SUBJECT: Utah Copper Division Modernization Project

UTAH COPPER DIVISION MODERNIZATION PROJECT
RESPONSE TO INFORMATION REQUEST
FROM THE UTAH BUREAU OF WATER POLLUTION CONTROL
OCTOBER 22, 1985

EXHIBIT "T"

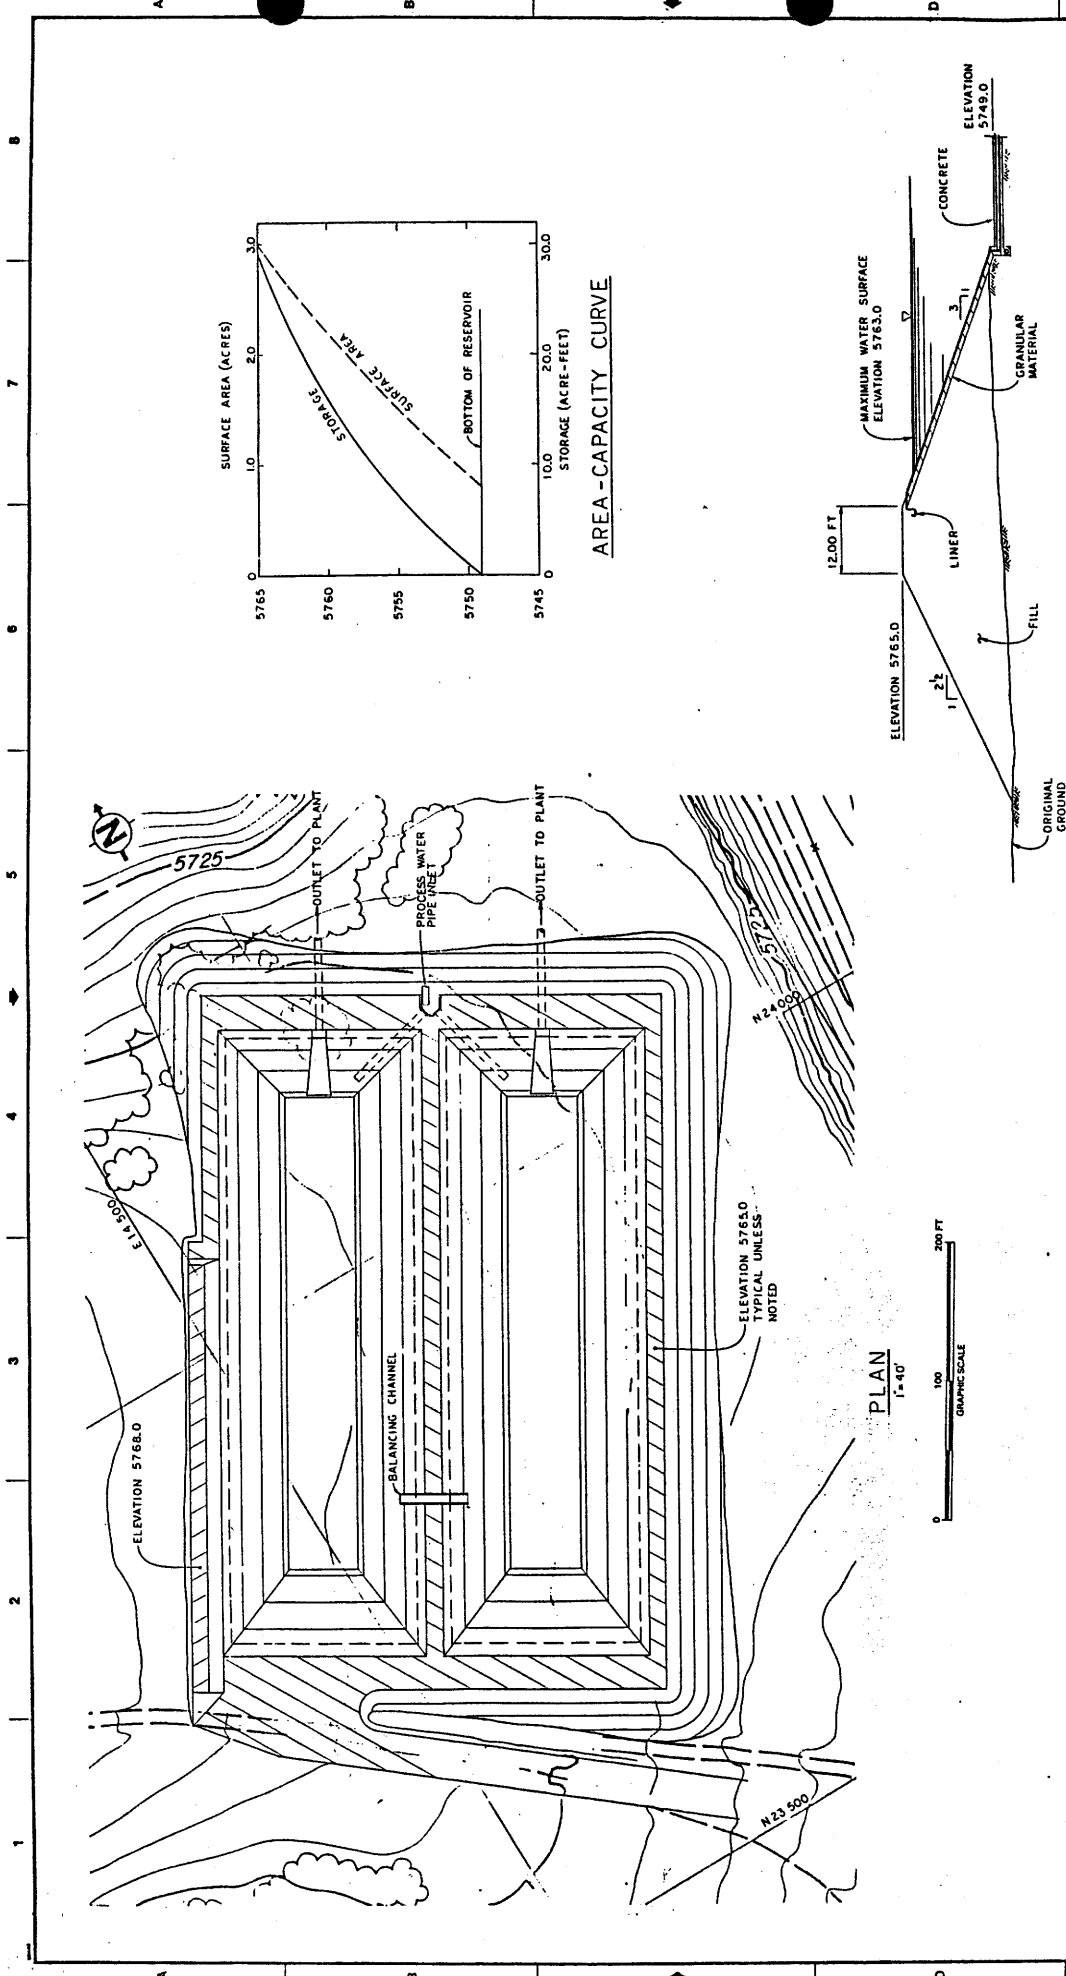
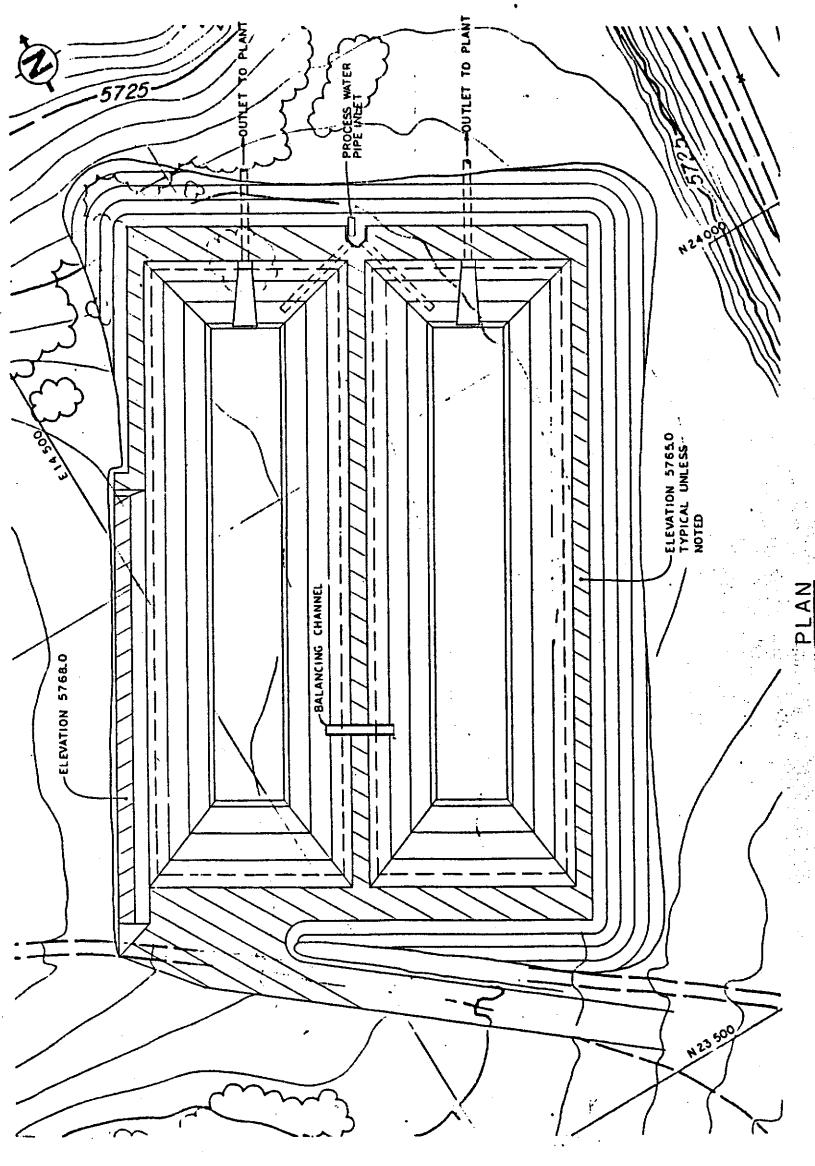
6.Q. The granular material specification for leak detection system and collection sump detail of the water supply pond should be provided.

7.Q. Specifications should be provided for riprap on water supply pond inlet to prevent wear on pond liner.

8.Q. Map and detail of process water leak collection system must be provided.

A. These details have been added to Exhibit U, enclosed.

A. This detail has been added to Exhibit U, enclosed.

A. This information has been added to Exhibit U, enclosed.

EXHIBIT "W"

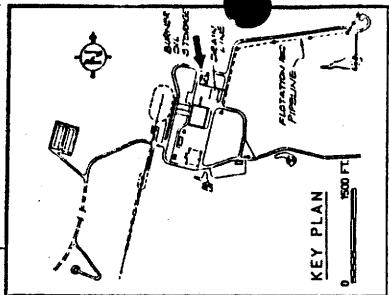
4.Q. Design detail of fuel storage containment and moly plant settling pond showing liners to be used must be provided.

A. Detail of the burner oil storage containment is shown in the enclosed Exhibit W. The containment will be constructed of concrete. Burner oil will be used as a reagent, not as a fuel. A moly plant settling pond will not be constructed.

PROCESS WATER RESERVOIR
LINER DETAIL

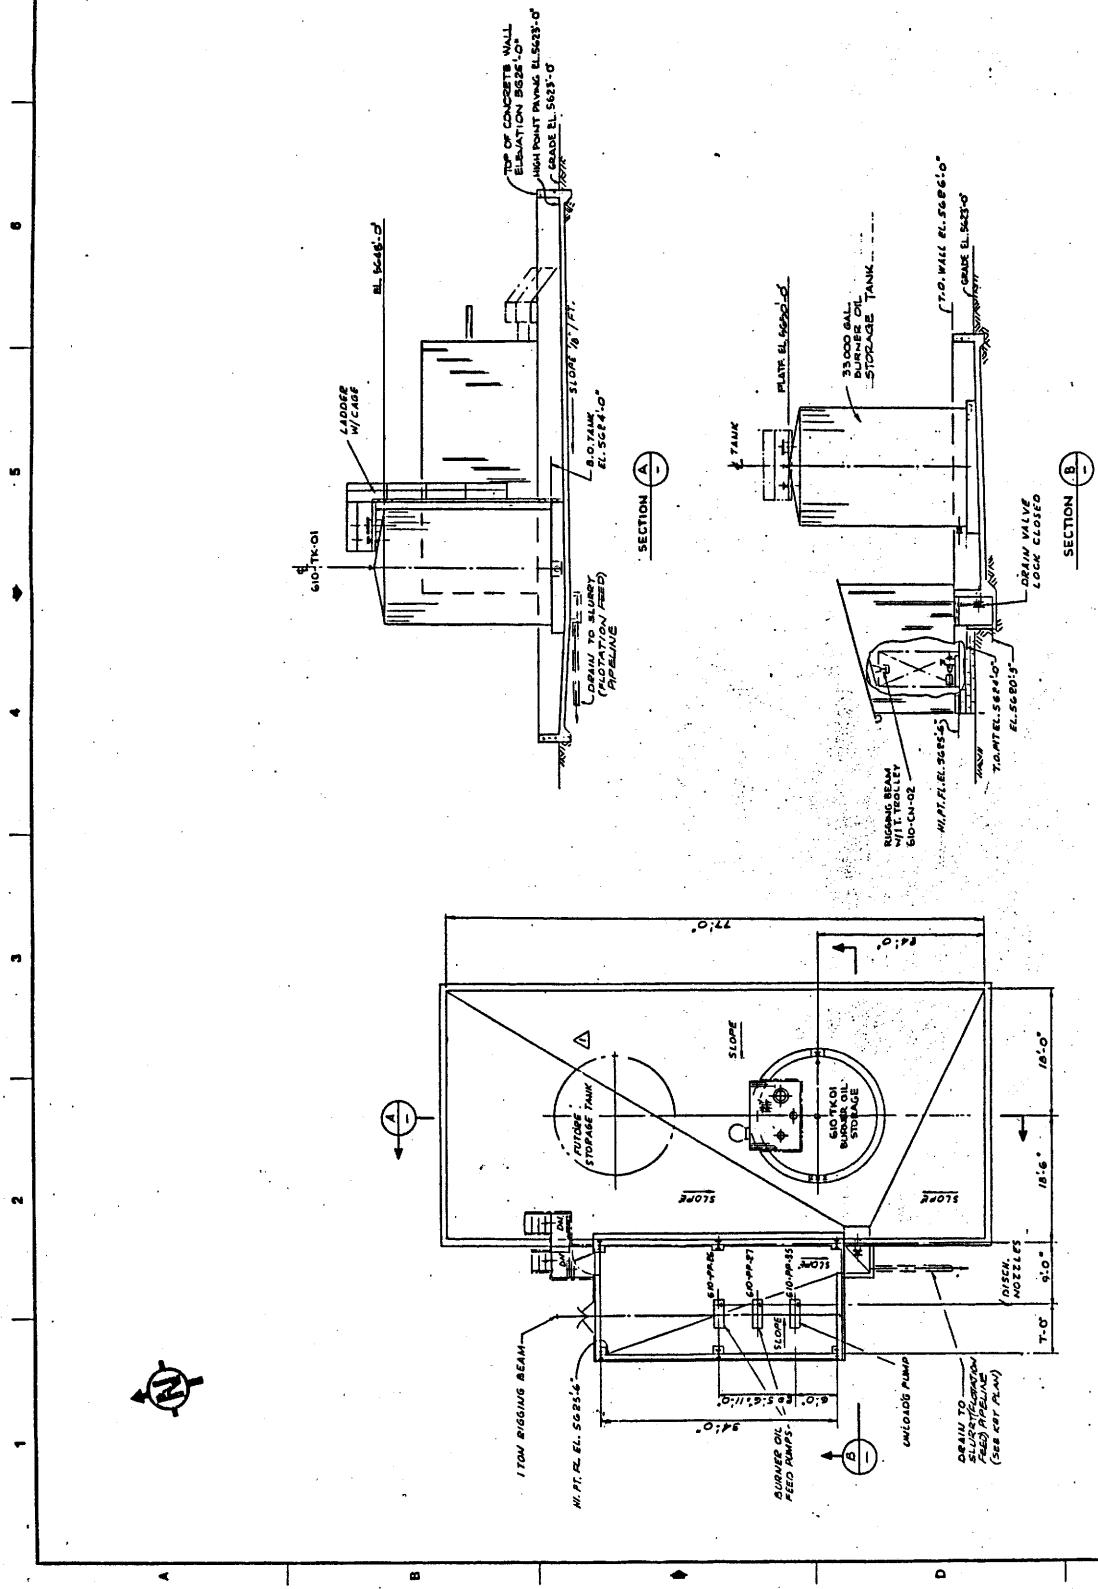
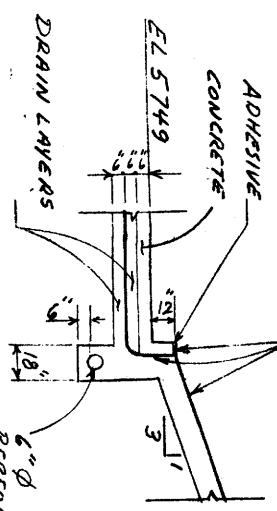
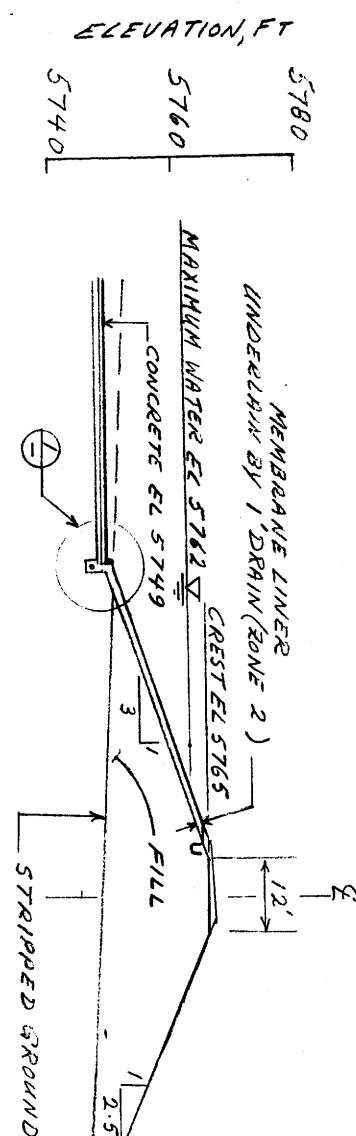
- 2.Q. The specification on the bottom liner for the storm runoff retention structures, liner thickness specification and laboratory tests results on liner material are required and the source of such material should be identified.

- A. Local material will be used for pond lining. The borings and test pits in the ponds showed the surface materials to be clays and clayey gravel with some silt and silty gravel. Samples from these surface materials (clay and clayey gravel) were obtained from the test pits in the ponds. These samples were compacted to 95% of ASTM D 698 and tested for permeability. The laboratory permeability was in the range of 10^{-7} to 10^{-8} cm/sec as shown in Attachment A.

For design of the ponds, it is conservatively assumed that when compacted in the field, the permeability of the surface materials will be 10^{-6} cm/sec (2×10^{-6} ft/min).

NOTE: THE PERMEABILITY OF MATERIAL
UNDERLYING THE MEMBRANE LINER
AND DRAIN LAYER IN CUT AREAS
IS IN THE RANGE OF 10^{-3} TO 10^{-2} CM/SEC
